CERTIFICATE OF APPROPRIATENESS

Property: 1235 Columbia Street, Lot 3, Block 190, Houston Heights Subdivision. The property includes a historic 1,706 square foot, one and half story wood frame single-family residence and a rear detached storage shed situated on a 6,600 square foot (50' x 132') interior lot.

Proposal: New Construction – Construct a front detached carport. The carport will be setback 30' from the front property line, and will measure 10' wide, 23'-3" deep and 19'-6" to the ridge. The carport will feature a side gable roof with a 9/12 pitch and will be clad with cementitious horizontal lap siding.
See enclosed application materials and detailed project description on p. 6-22 for further details.

NORTH SIDE ELEVATION

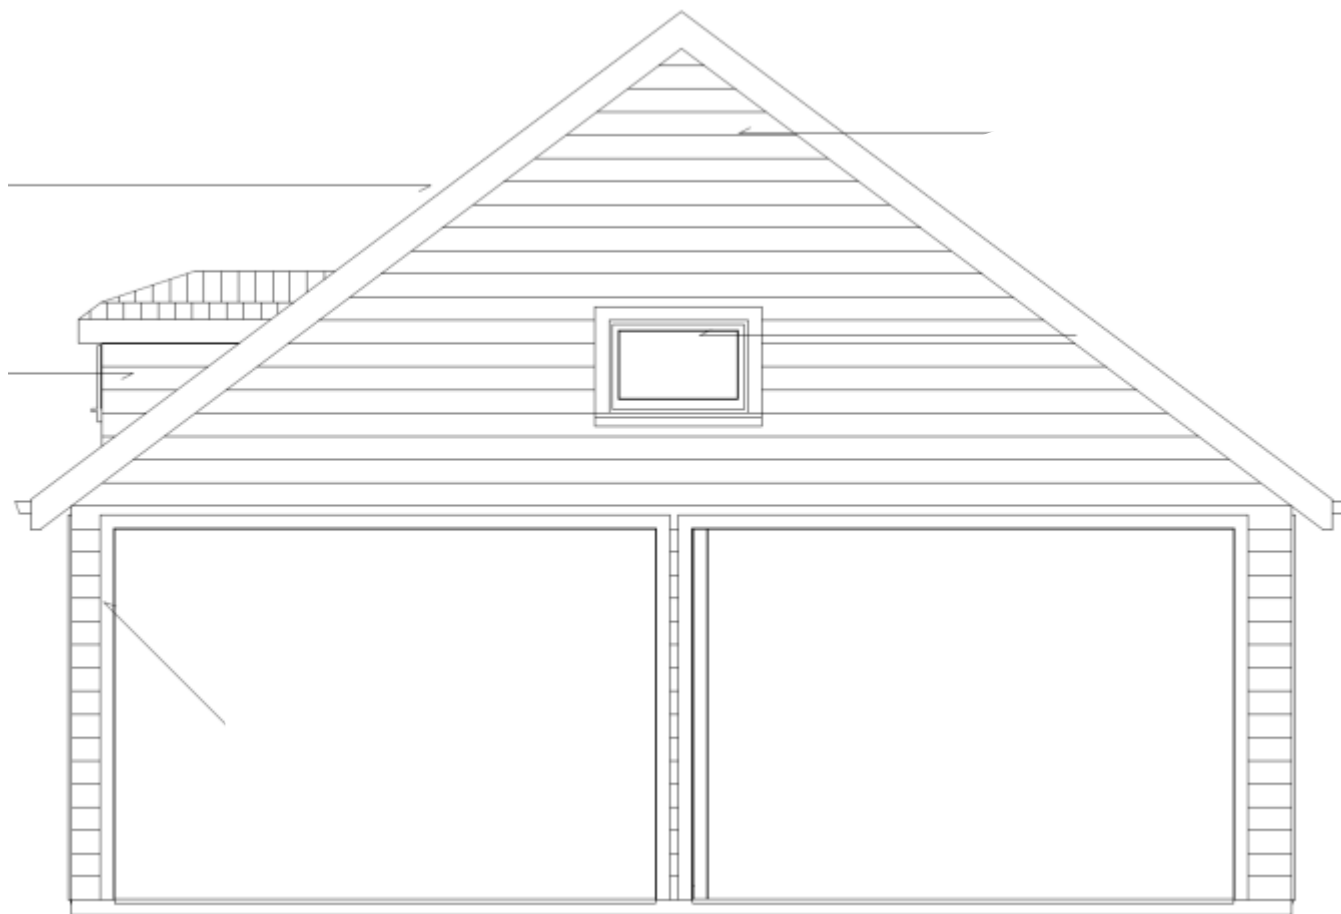
Side Elevation: The carport will feature two openings of equal size.
(North)

SOUTH SIDE ELEVATION

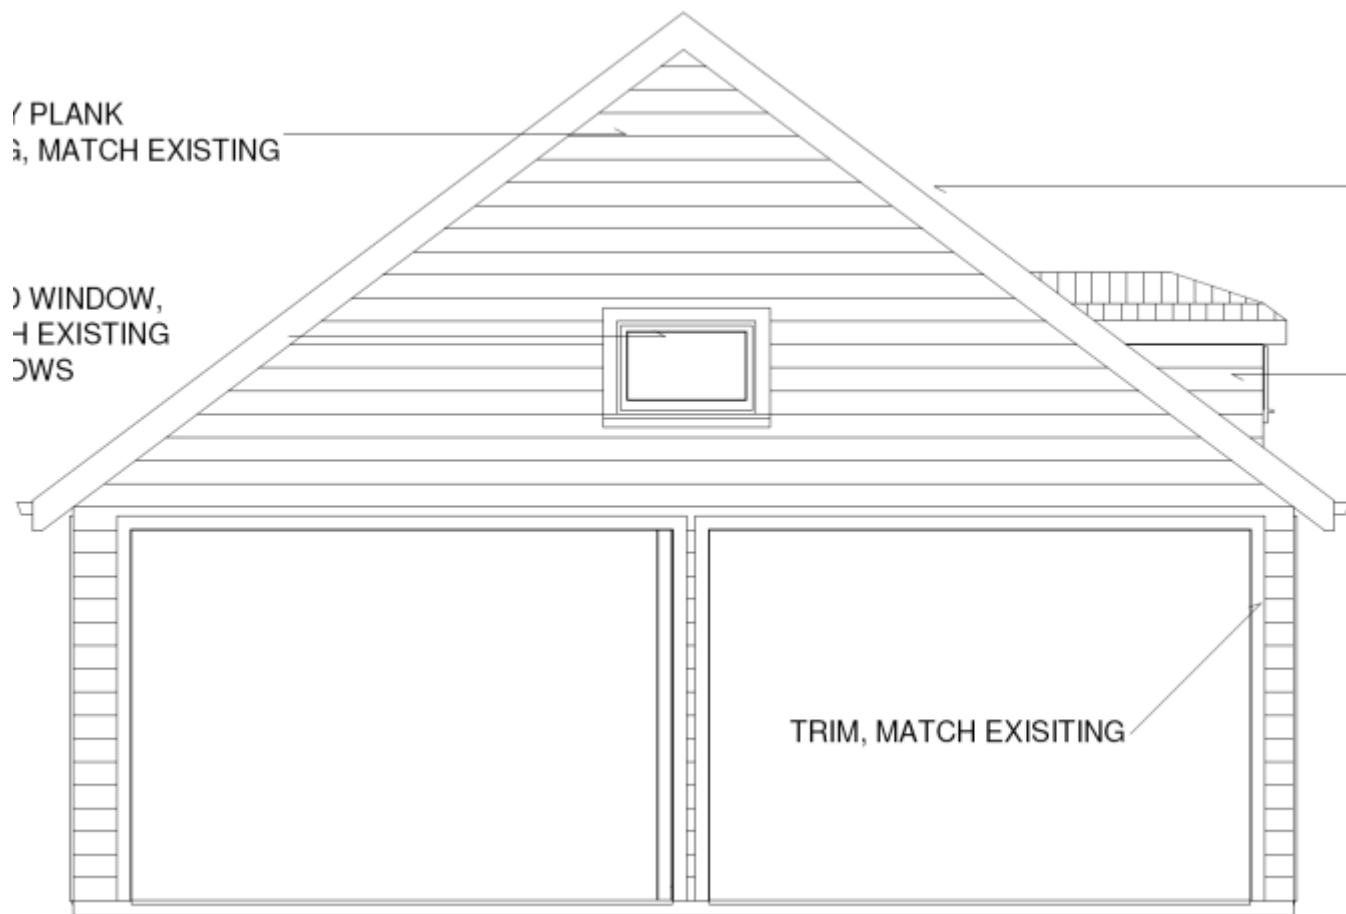
Side Elevation: The carport will feature two openings of equal size and the side gable will feature a single lite wood fixed window.
(South)
